# **DRAINAGE REPORT**

**COLORADO KIDS RANCH  
18065 SADDLEWOOD ROAD, MONUMENT, CO 80132**

**JPS Project No. 112301  
PCD Filing No. PPR**

**PPR2235**

**CO PUMPKIN PATCH  
DRIVEWAY CULVERT SIZING SUMMARY**

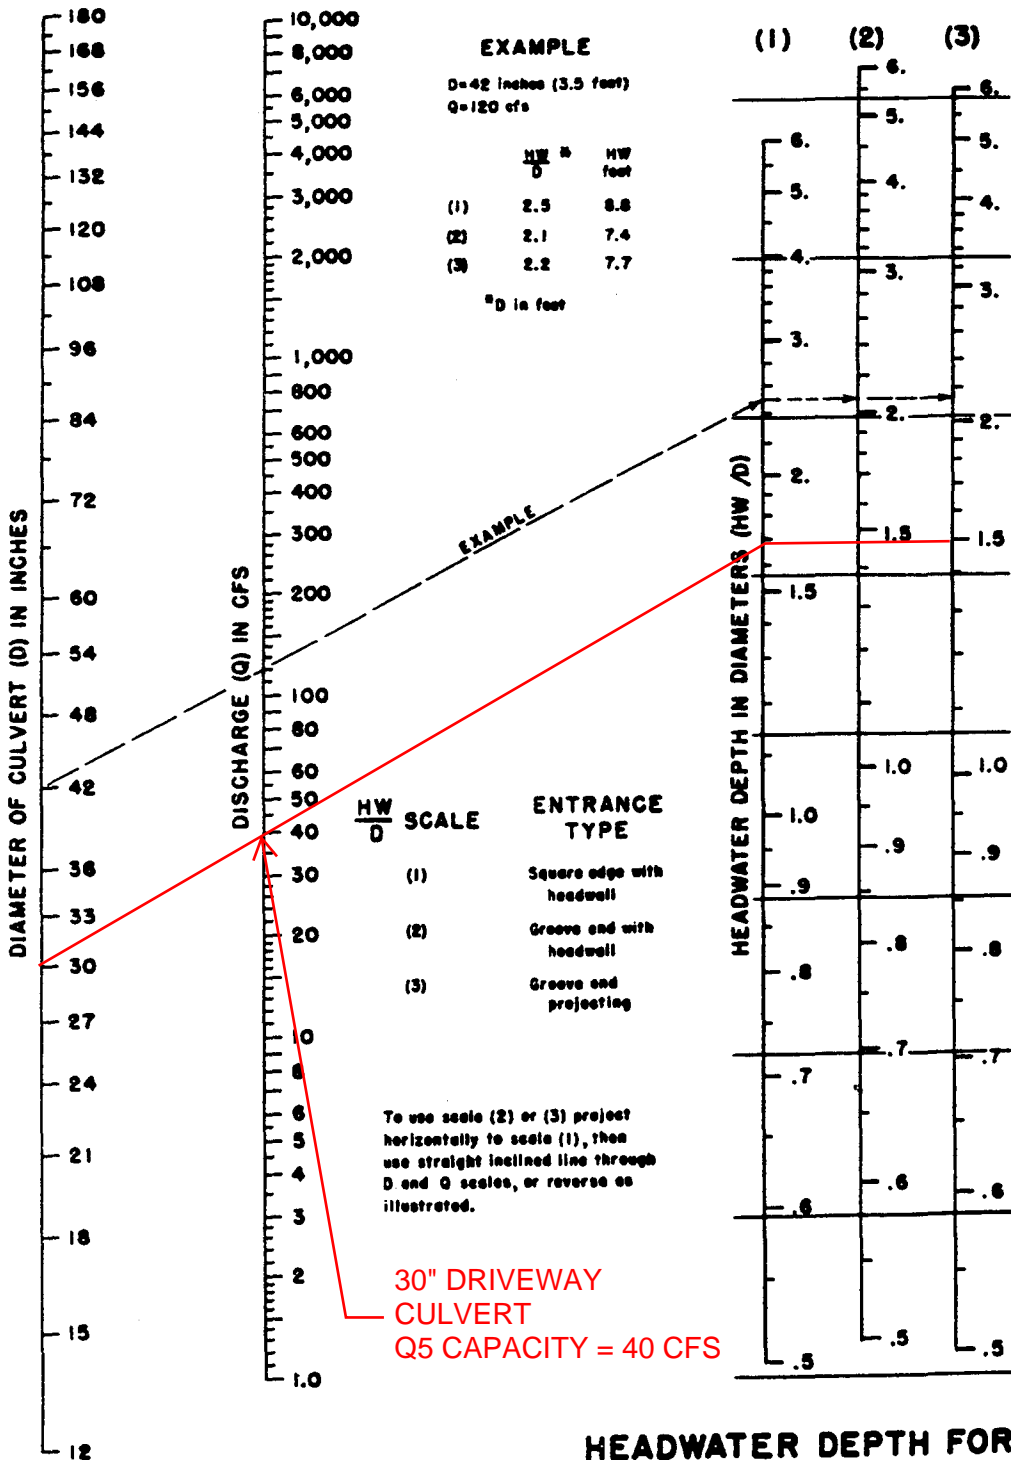
The figure on the next page actually shows this in the range of ~1.4-1.7, depending on the culvert entrance type. Please revise to remove discrepancy.

DEVELOPED  
DRAINAGE PLAN

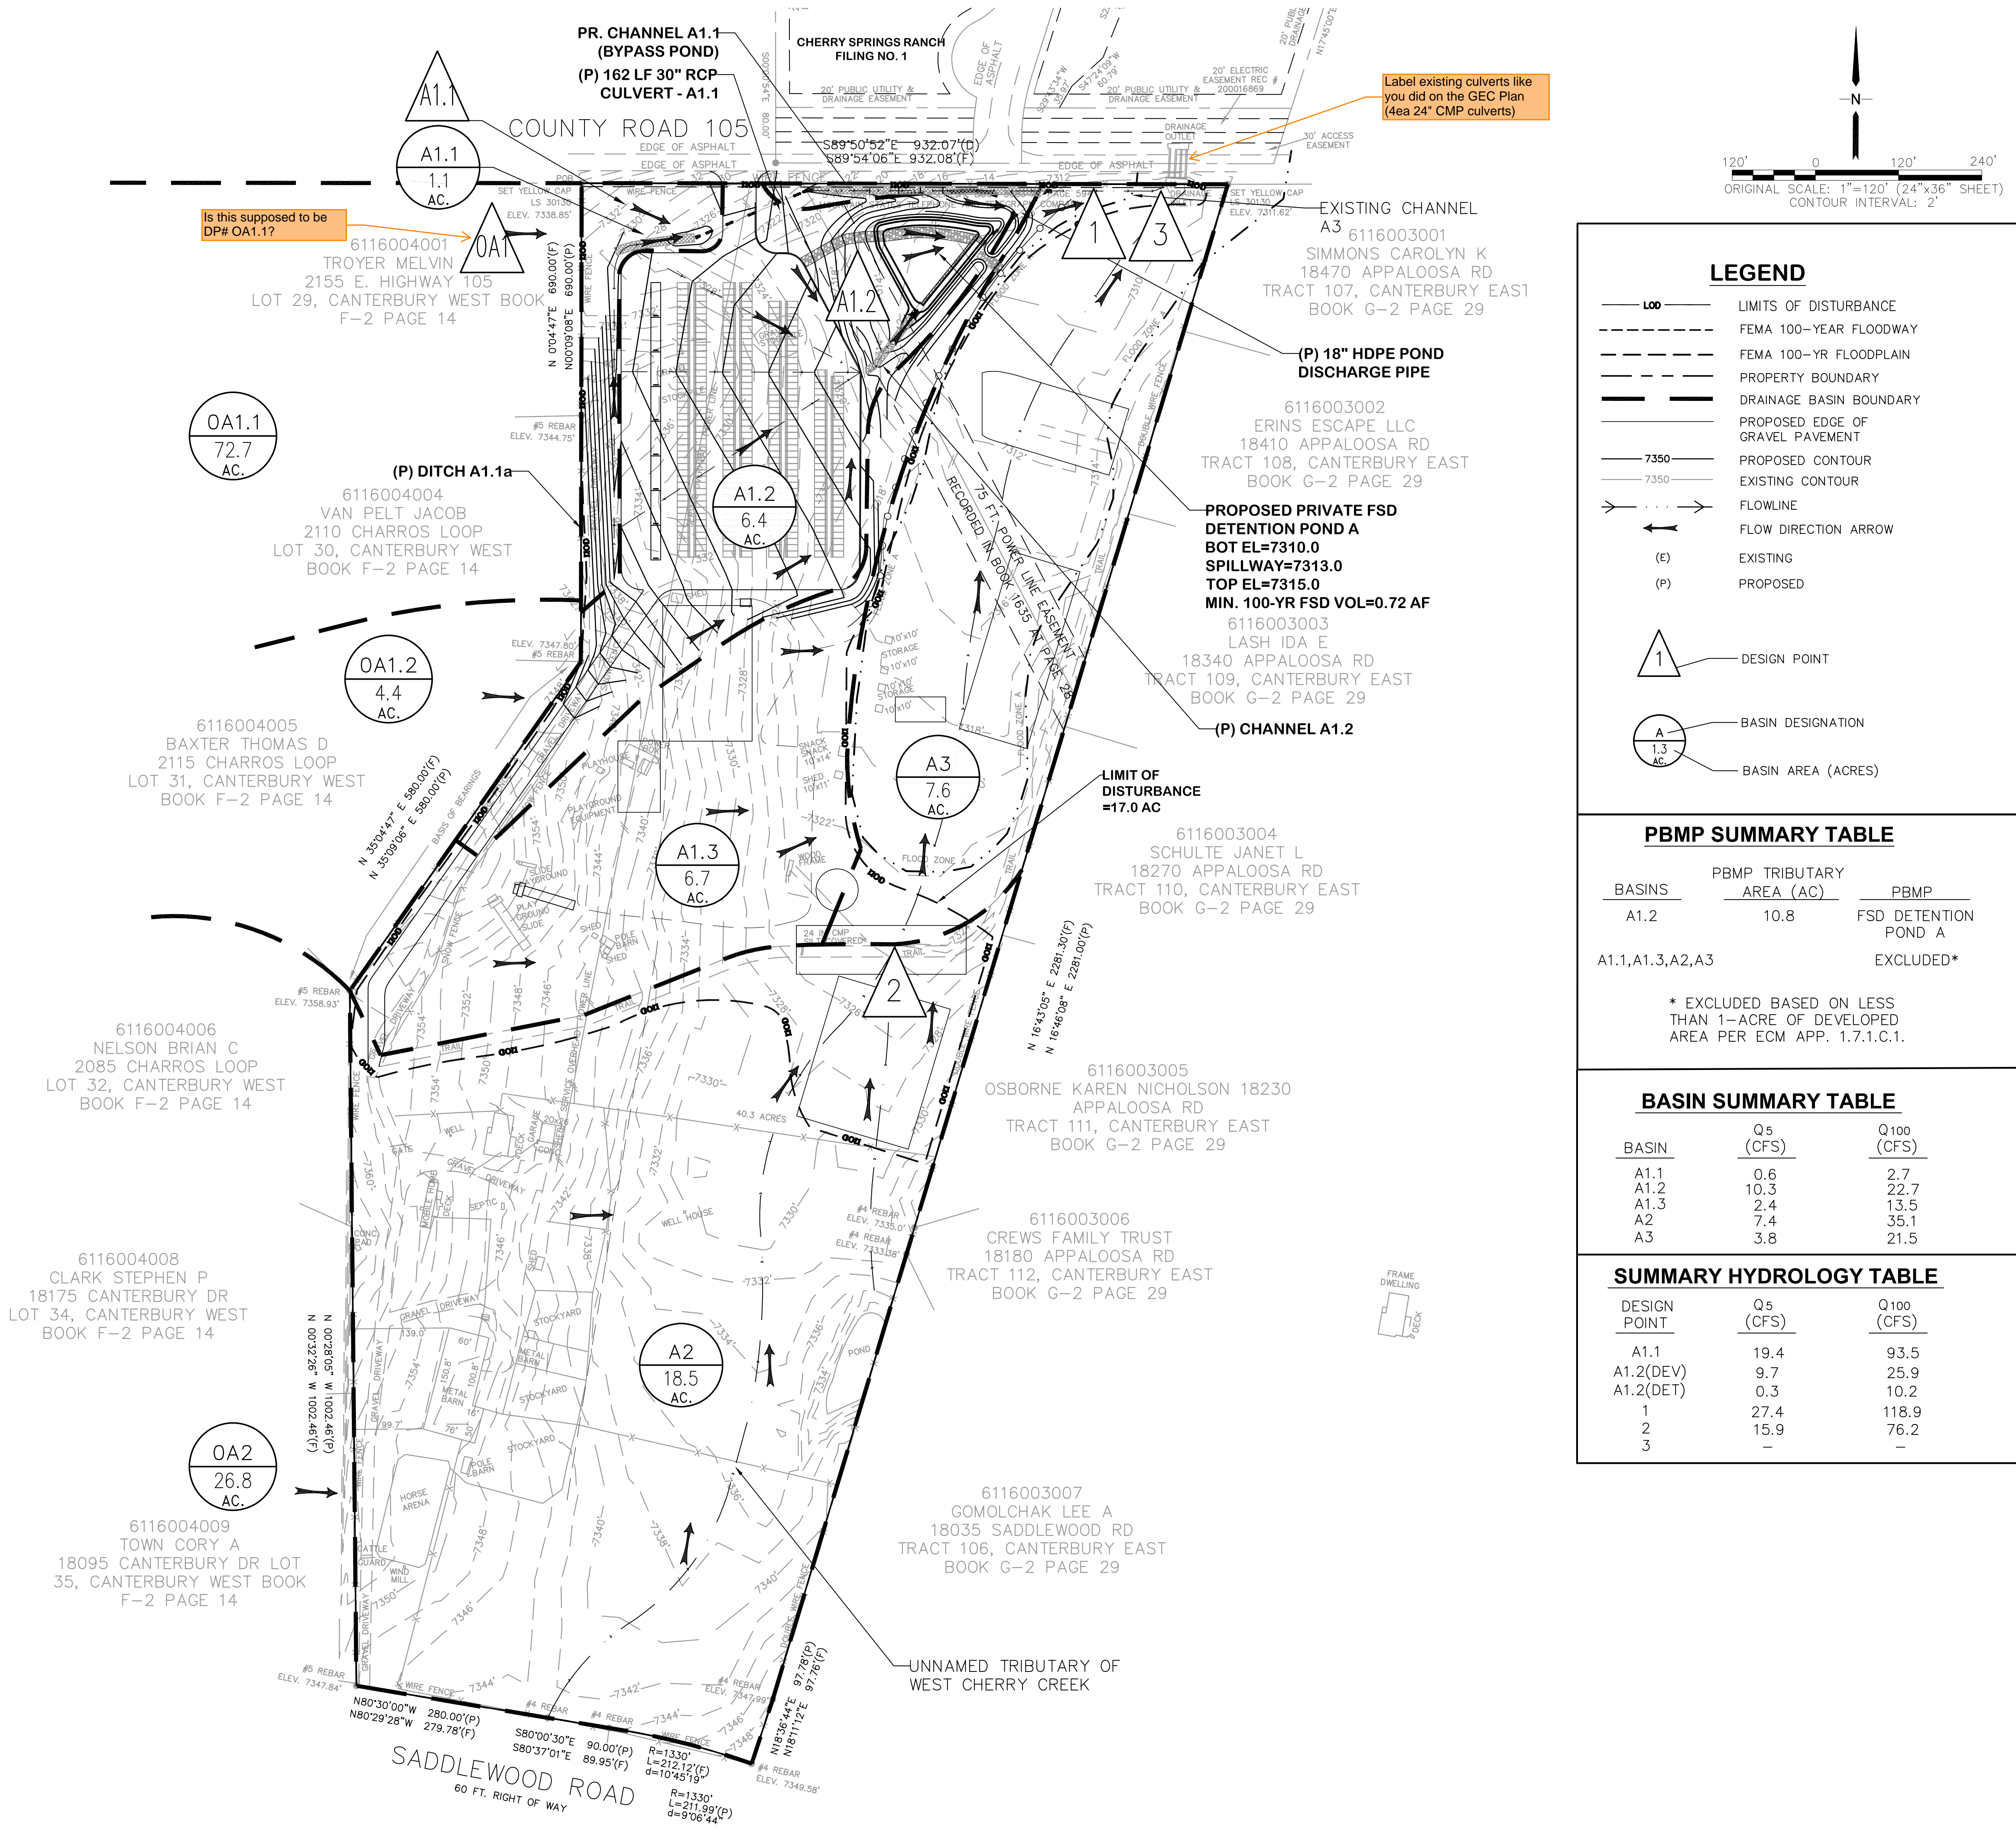
The highlighted DP's are not shown on the drainage map. Either delete these cells (not the rows) since these basins just sheet flow or somehow clarify this discrepancy on the drainage map. For example: add them to the map as DPs or add a note on the map and this table explaining why they aren't on the map.
